DATE: August 21, 2013

SUBJECT: Addendum No. 1
U.S. 50/Silva Valley Interchange
PW 12-30647, CIP No. 71328

DIST	COUNTY	ROUTE	POST MILES TOTAL PROJECT	SHEET No	TOTAL SHEETS
03	ED	50	1.07/R2.40	340	371

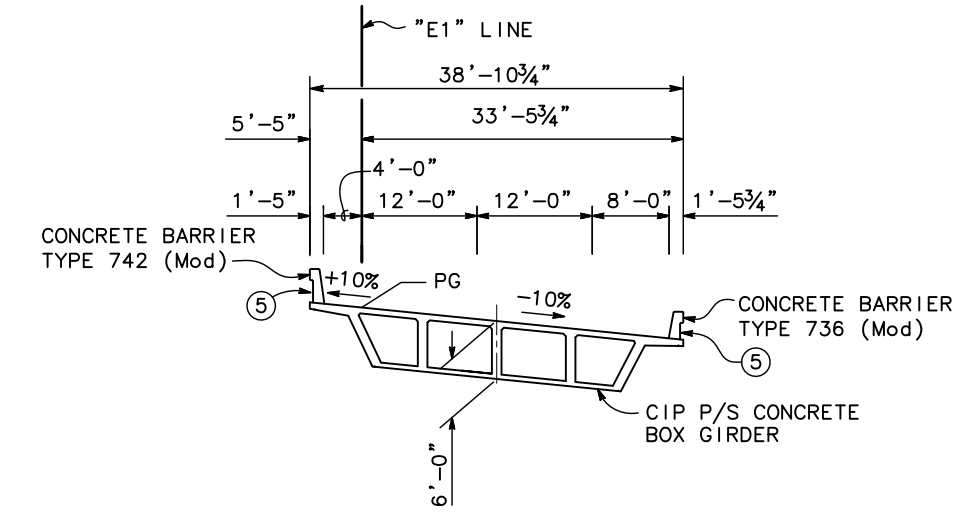
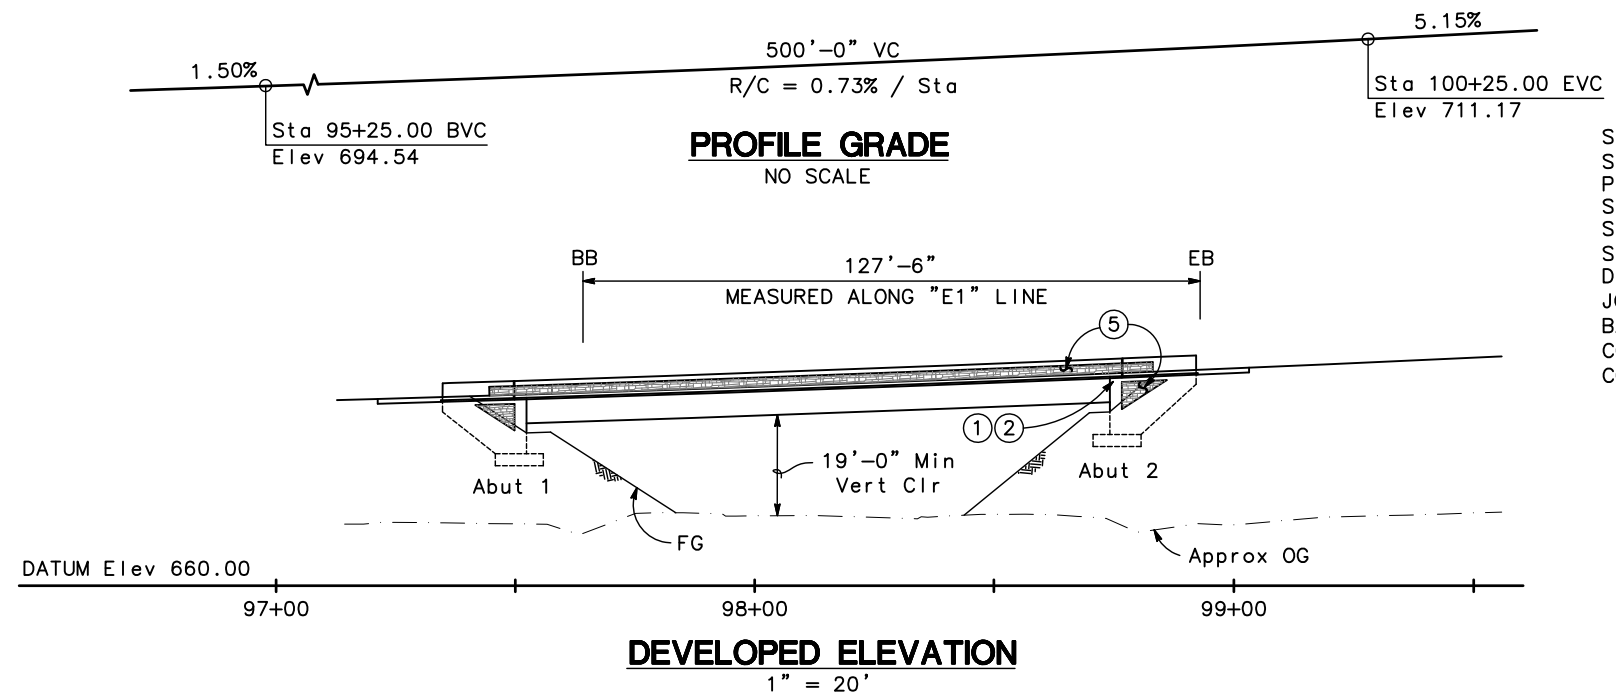
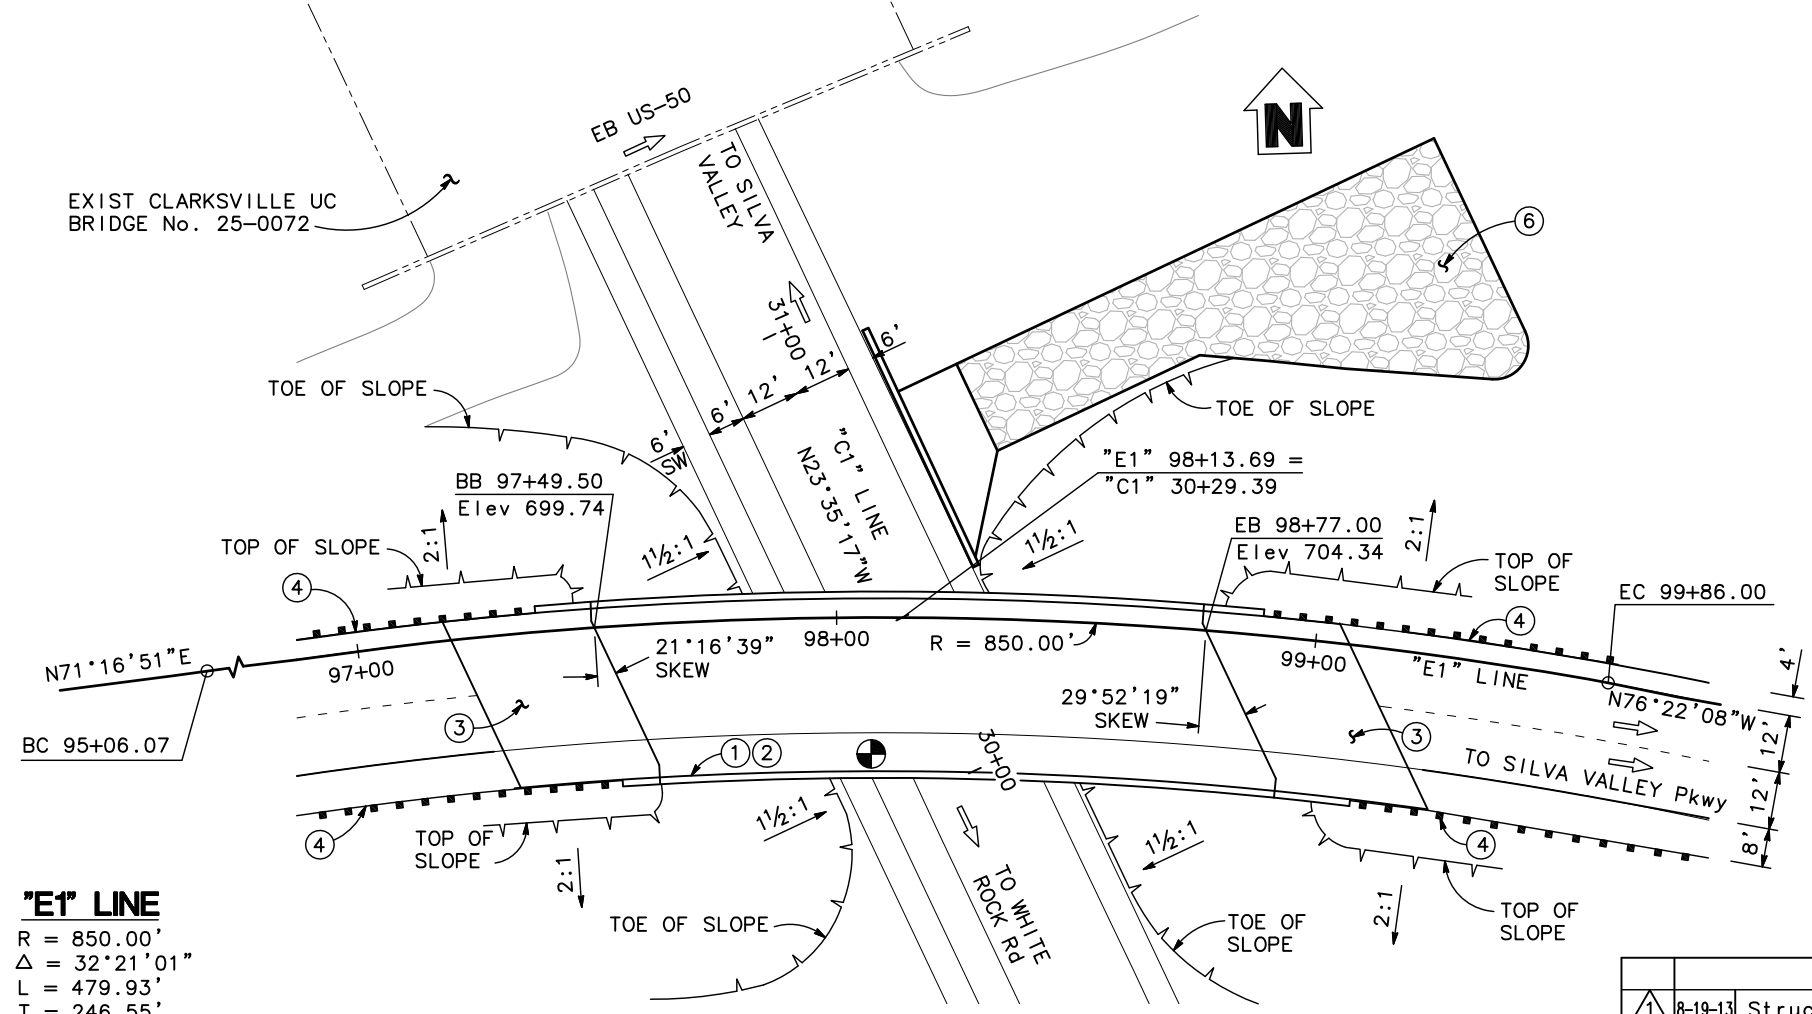
1. 26.	Plan sheet 340	Bidders are instructed to replace Plan sheet 340 with revised Plan sheet 340 attached to this Addendum.
1. 27.	SP-69	Add to the first sentence of Section 13-11.01C after "...in this Certification": "and to the California Department of Fish and Game before commencement of diversion." Add to the last sentence of Section 13-11.01C ", the Streambed Alteration Agreement, and the U.S. Fish and Wildlife Service requirements." Replace section 13-11.02 with "Any temporary dam or other artificial obstruction constructed must only be built from clean materials such as sandbags, gravel bags, water dams, port-a- dams, water bladder dams, K-rails, driven sheet metal coffer dams, or clean/washed gravel which will cause little or no siltation."
